ISSUED FOR USE  
EBA FILE: W14101068.037

**Subject:** Mill Water Pond – 2011 Annual Review, Minto Mine, YT

**MILL WATER POND - 2011 ANNUAL REPORT  
MINTO MINE, YUKON**

**Figure 1**

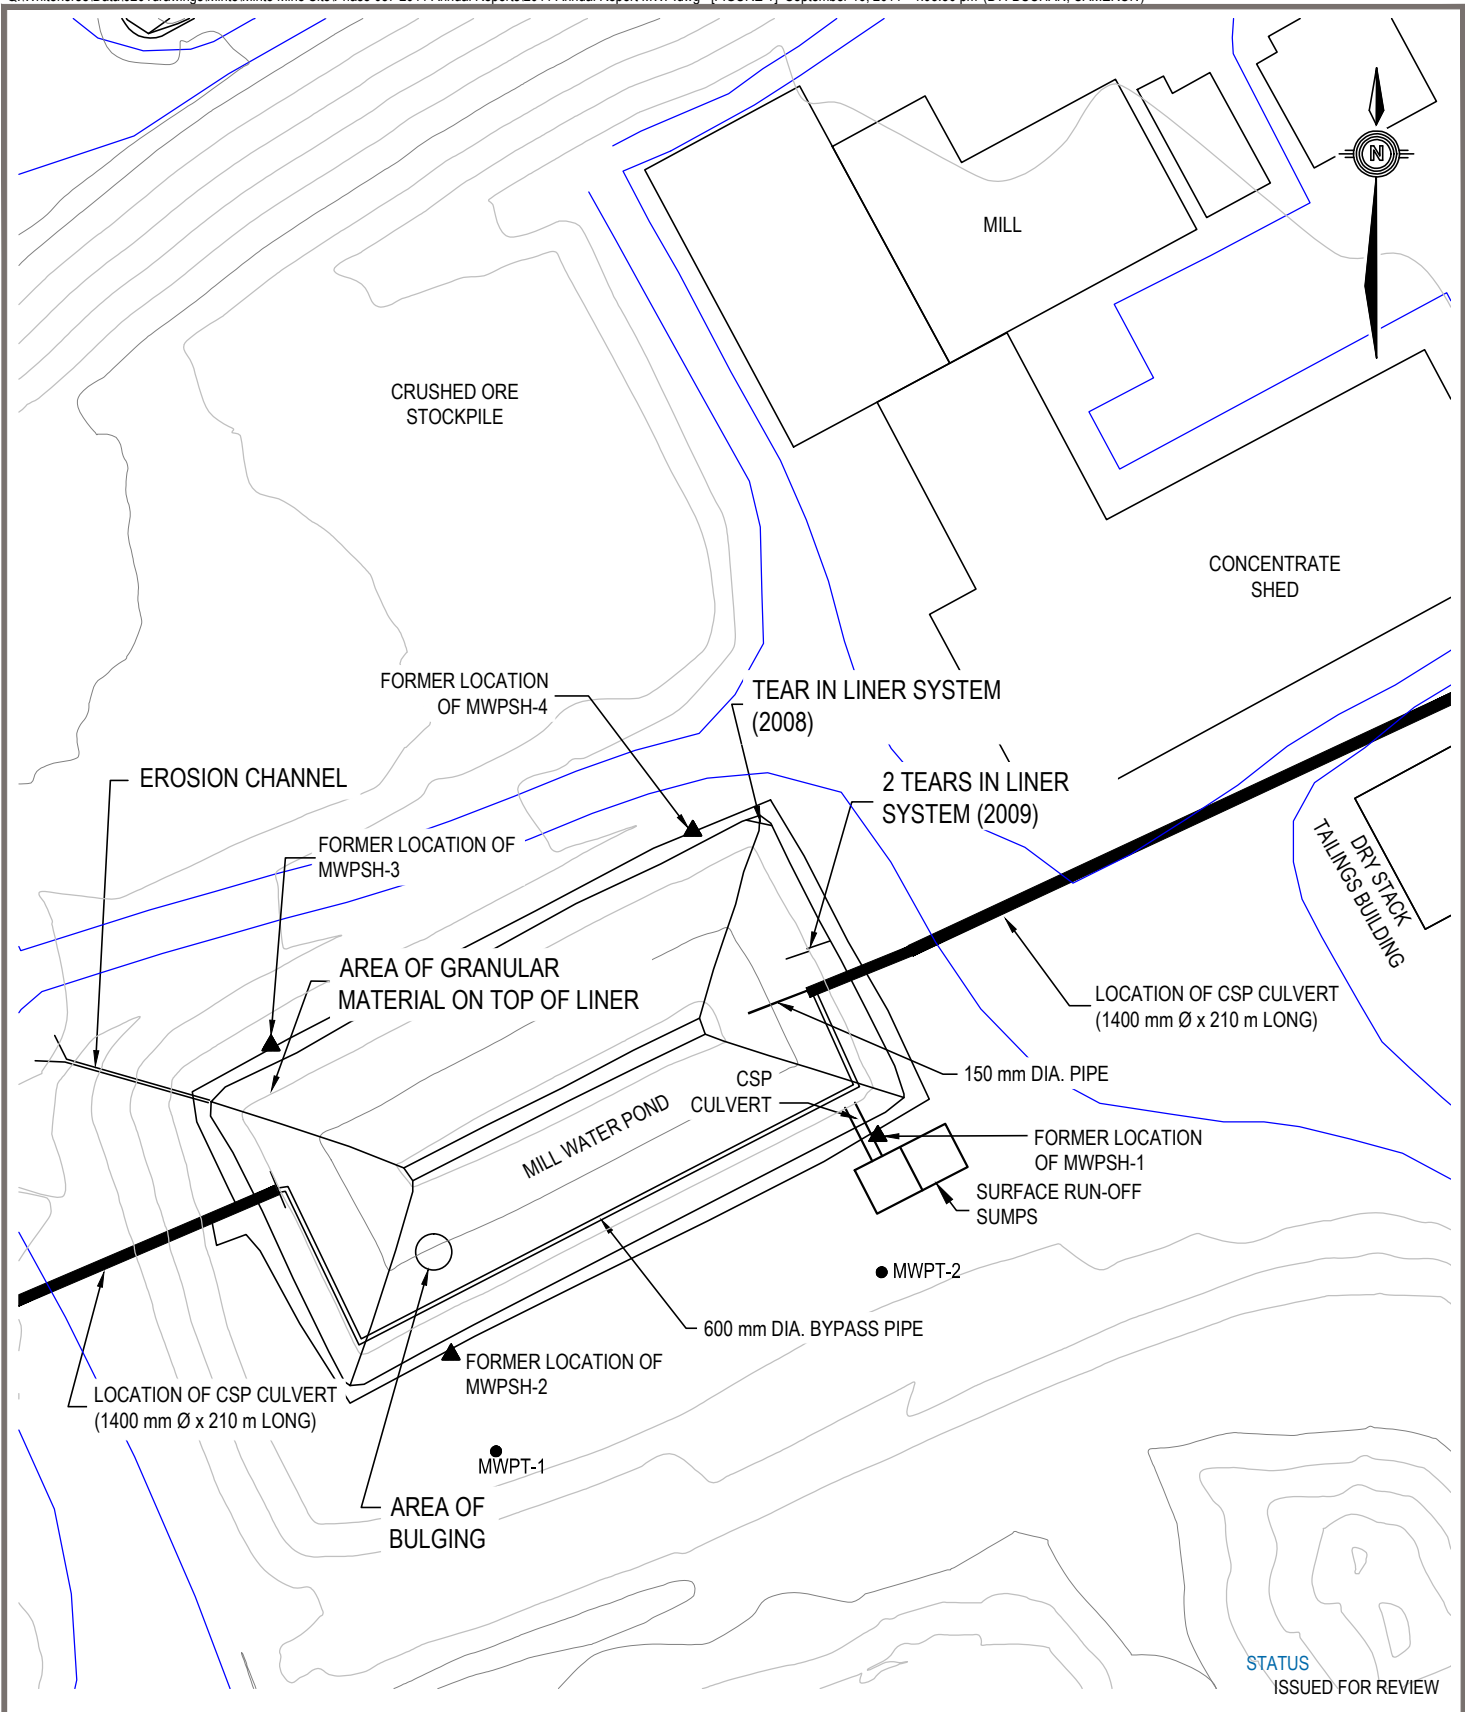
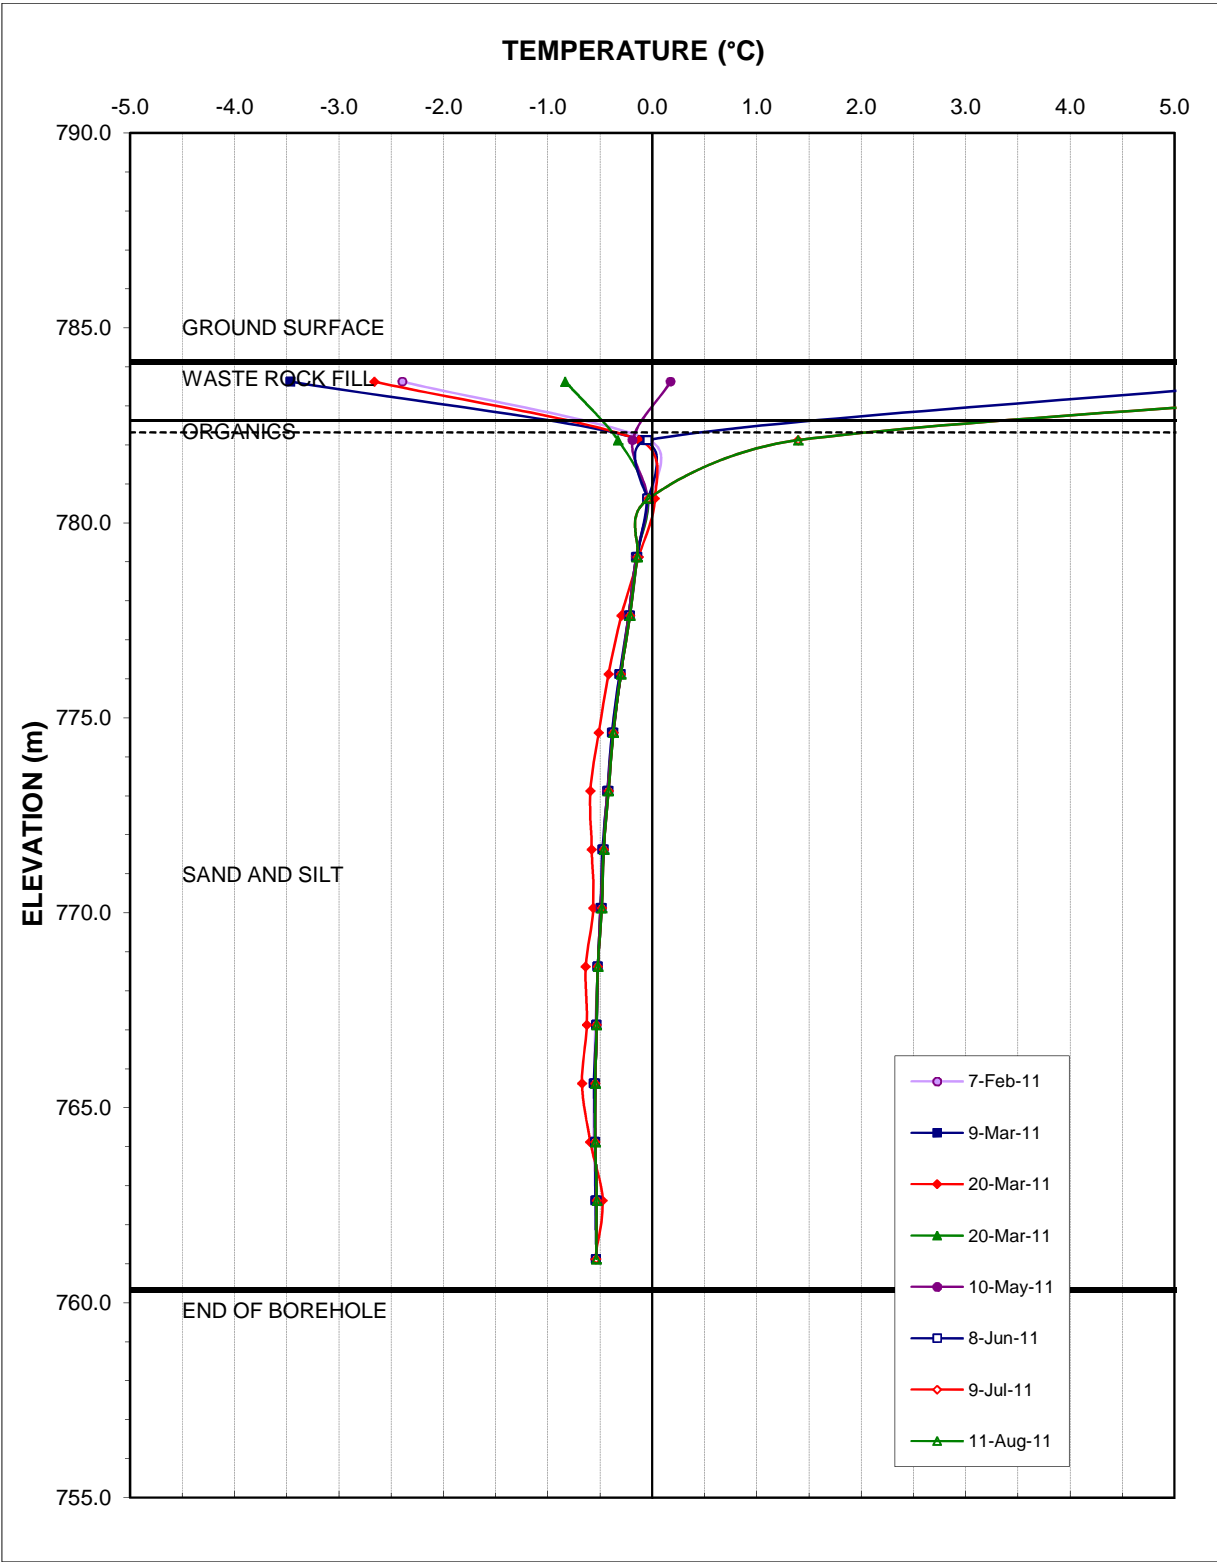
Mr. Chad Cowan, P.Eng., of EBA's Whitehorse office completed a site visit on August 25, 2011. Specific details are presented below, and are also noted on Figure 1 attached to this letter. Photographs were taken of the pond during the visit. Selected photos are attached while the remainder are available for review in the EBA files, if desired.

- Although difficult to tell because of the water level within the MWP, the slopes of the cell still appear consistent with construction with no signs of slumping or bulging noted with the exception of what appears to be a minor bulge under the liner system in the vicinity of the southwest corner. This bulge is just visible (Photo 2) at the water level elevation at the time of the site visit. The potential bulge noted in the northeast corner during the 2007/2008 review does not appear to have changed over the past few years.

The location of these instruments is shown in Figure 1.

Once the water level drops during regular operation, the observed bulge in the vicinity of the southwest corner should be inspected further.

Mill Water Pond  
Ground Temperature Profile - MWPT-1  
Figure T1

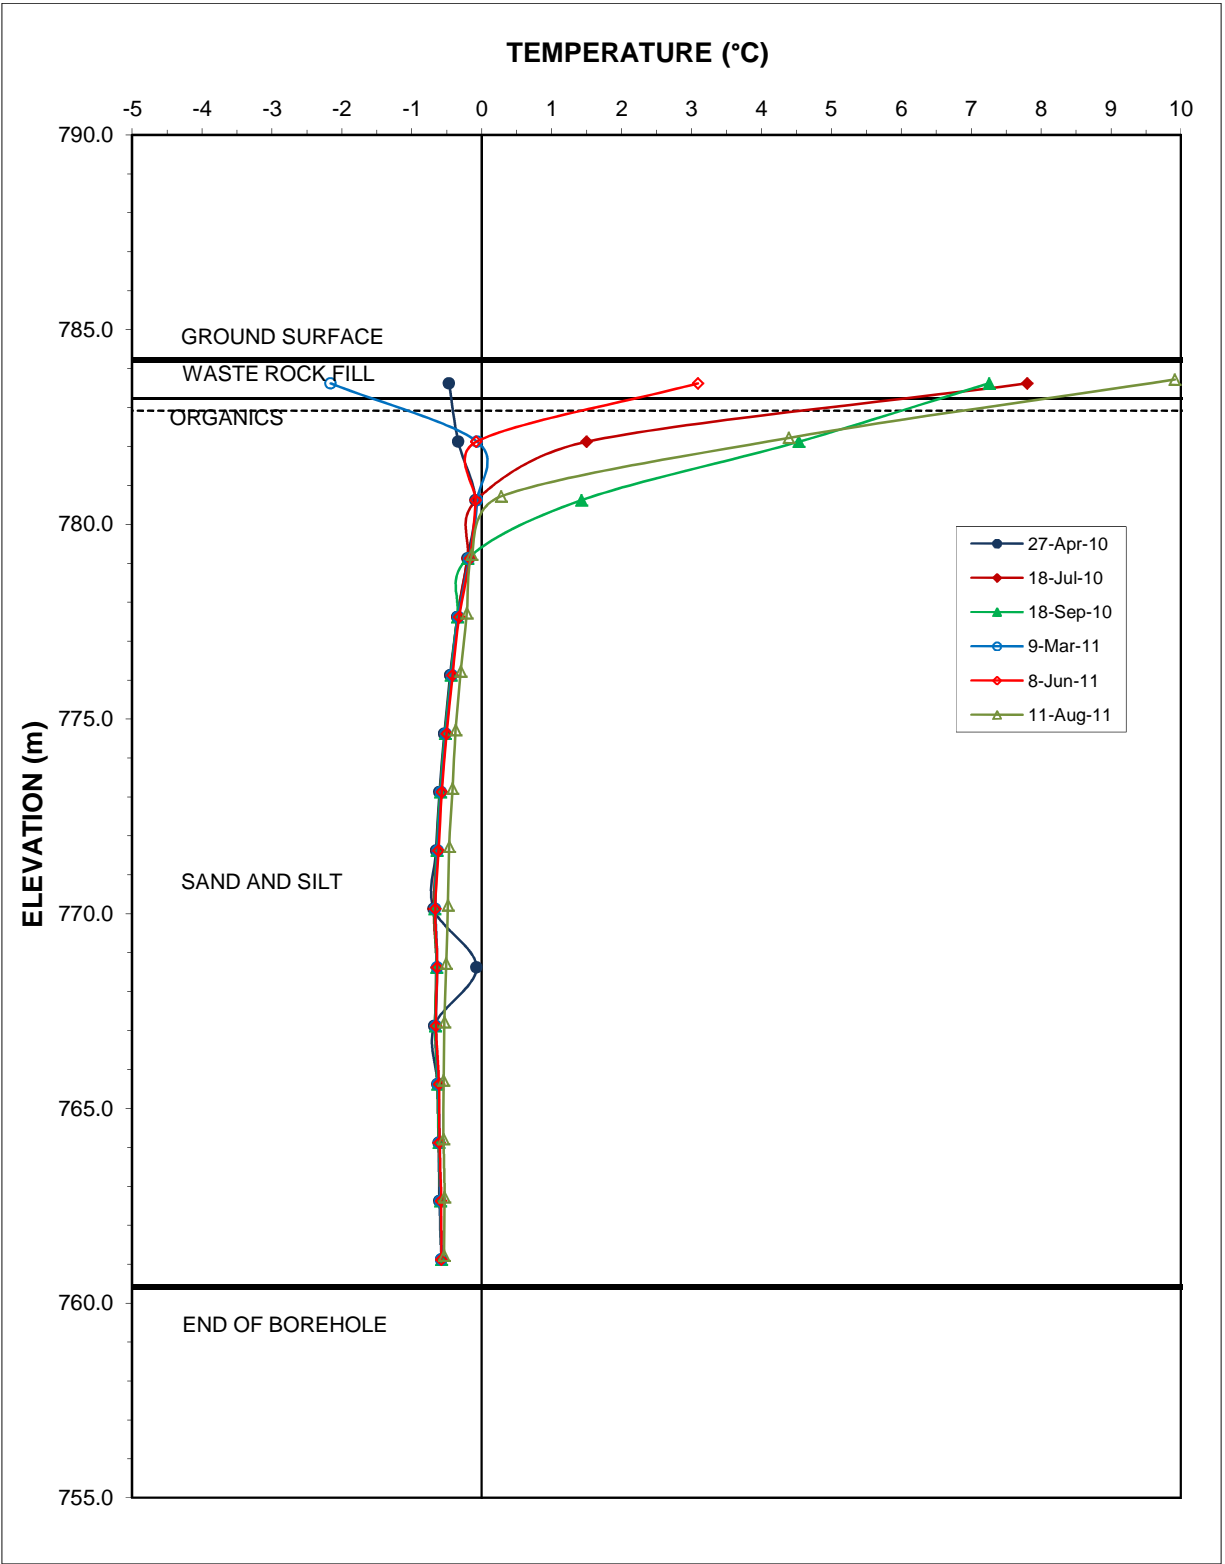
Ground temperature profiles from the two ground temperature cable locations are presented in Figures T1 and T2. The two profiles indicate that permafrost in the foundation soils within the vicinity of the pond has been maintained to date. The active layer extended to a depth of 4.3 m in August 2011, this is slightly deeper than the active layer depth noted in September 2010.
